**UNDER** the Resource Mangement Act 1991 ("RMA")  
**IN THE MATTER** of a resource consent application to the Taranaki Regional Council for the application by Remediation (NZ) Limited

**STATEMENT OF EVIDENCE OF HAYDEN RUSSELL EASTON ON BEHALF  
OF REMEDIATION NEW ZEALAND LIMITED**

# Uruti Composting Facility – Water Quality Management

**Figure 1: Cummulative rainfall recorded at the Taranaki Regional Council operated rainfall station (Uruti @ Kaka Road) two weeks prior to my site visit conducted on 4 February 2021.**

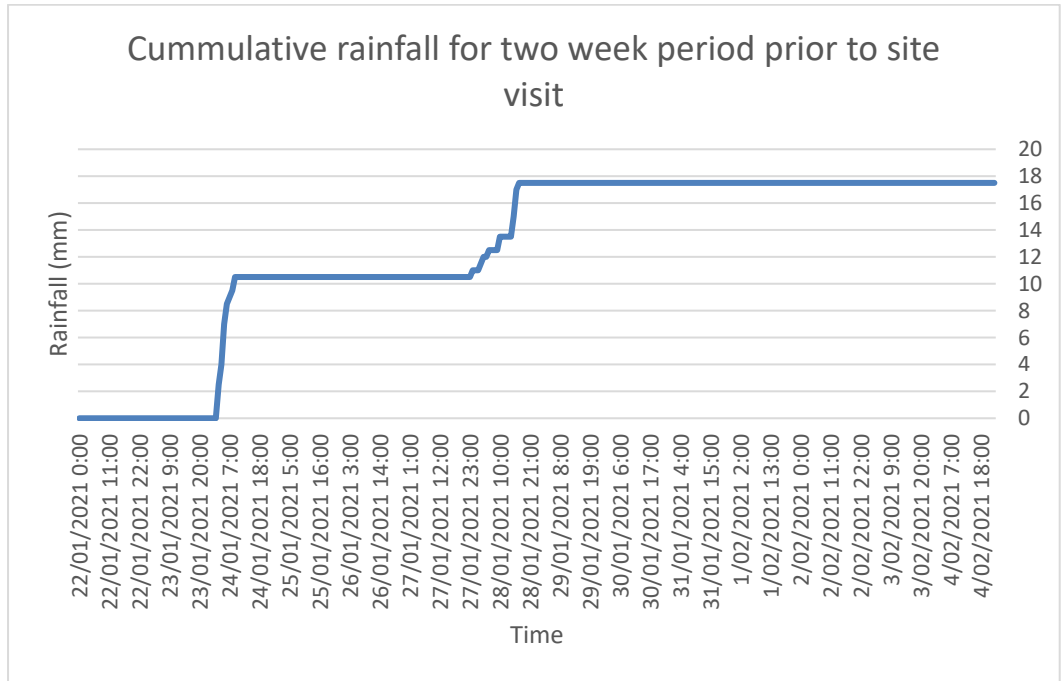
4.4 As Figure 1 suggests, 17.5 mm of rainfall was measured at the Uruti @ Kaka Road rainfall monitoring site in the two weeks prior to my site visit. Specifically, no rainfall had occurred for six days prior to the site visit.

4.5 I have also reviewed the report 'Haehanga Catchment Preliminary Groundwater Investigation', a report prepared by BTW Company. This report suggests that groundwater levels are on average 0.81 m below ground level. The report also suggests that groundwater ingress to the ponds is possible.

- 4.6 Given that there is a potential that pond levels maintained by groundwater ingress, I recommend that a permeability test of the pond liners be conducted. This could be provided for as a condition of consent.

- 4.7 Should it be identified that the permeability of the pond liner is greater than  $1 \times 10^{-9}$  m/s, a new liner should be installed.
- 4.8 Ms McArthur also claims that the site had completely uncontrolled stormwater runoff during her site visit. She supports this claim with several photographs during her visit (photos 1 a and b).

Surface Water Monitoring Locations

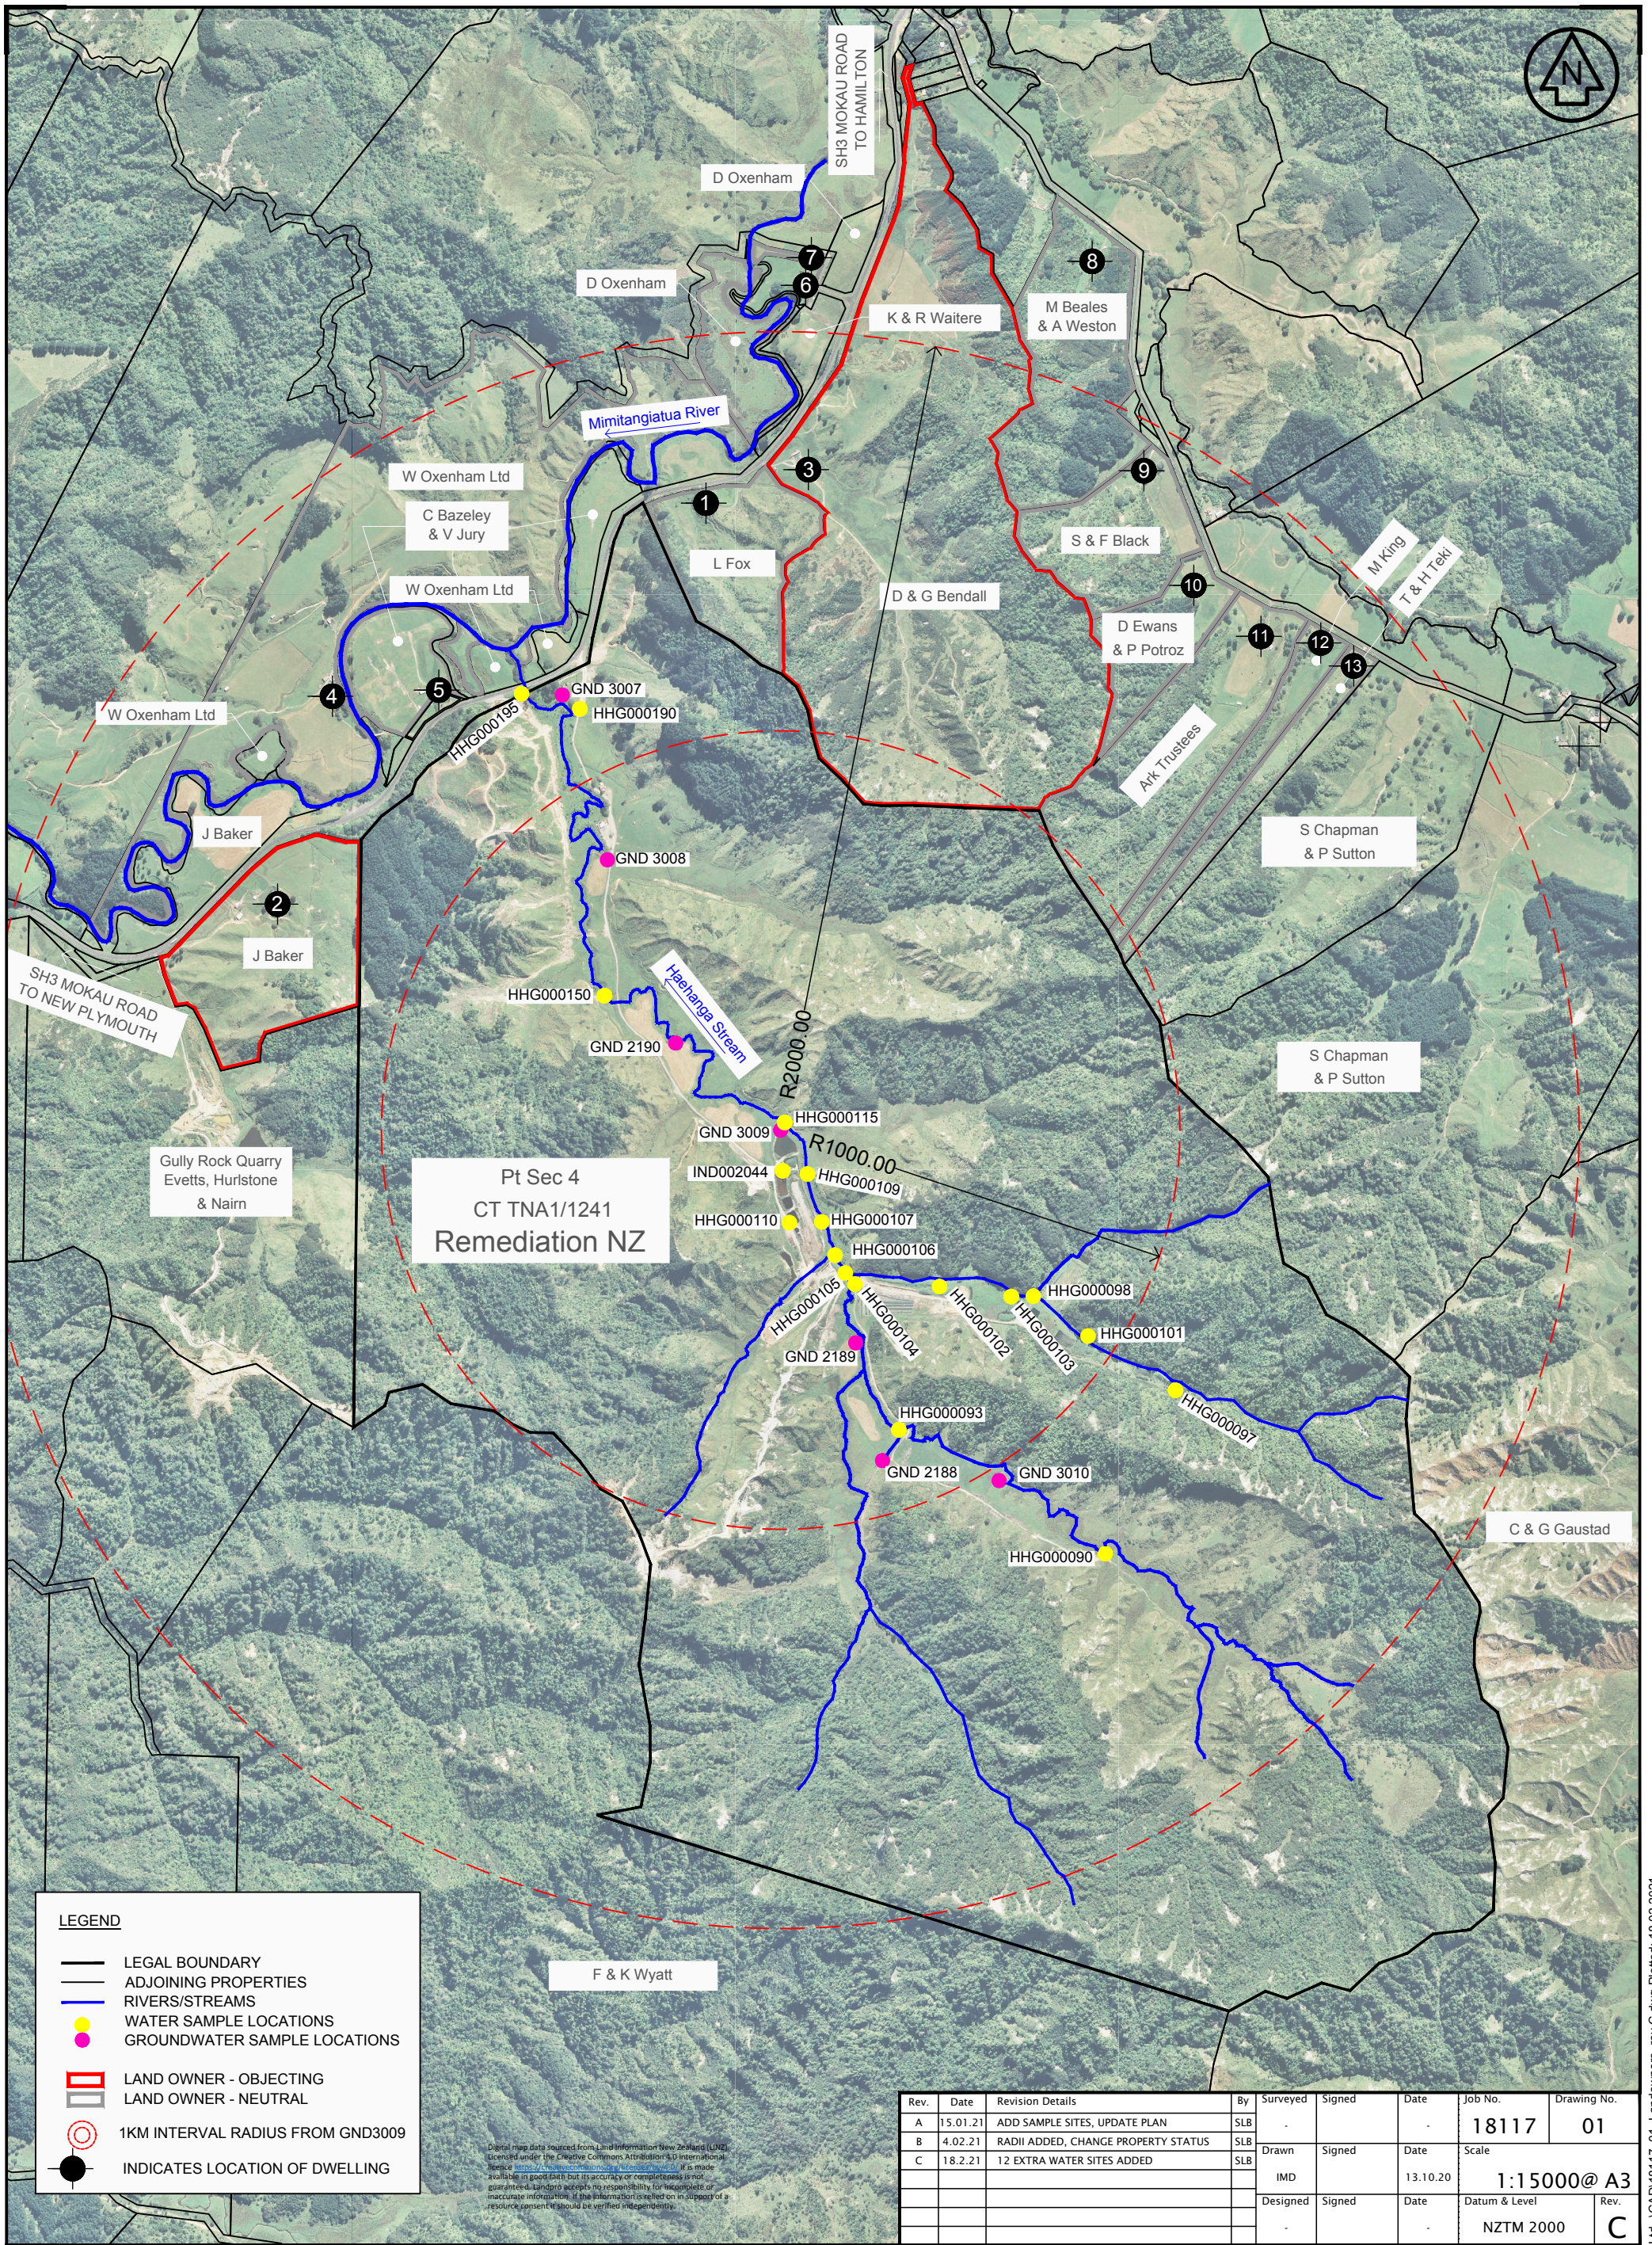
Based on the results presented in Table 1 there are a number of monitoring locations where TAN results (medians and maximums) do exceed the national bottom line. In reference to the monitoring location map, all non-exceedances to the NPS:FM 2020 are located upstream of Uruti Composting Facility. As such, the submission that concludes that the water quality discharges from the Uruti Composting Facility are contributing to Haehanga Stream TAN concentrations exceeding the NPS:FM 2020 bottom line is correct.
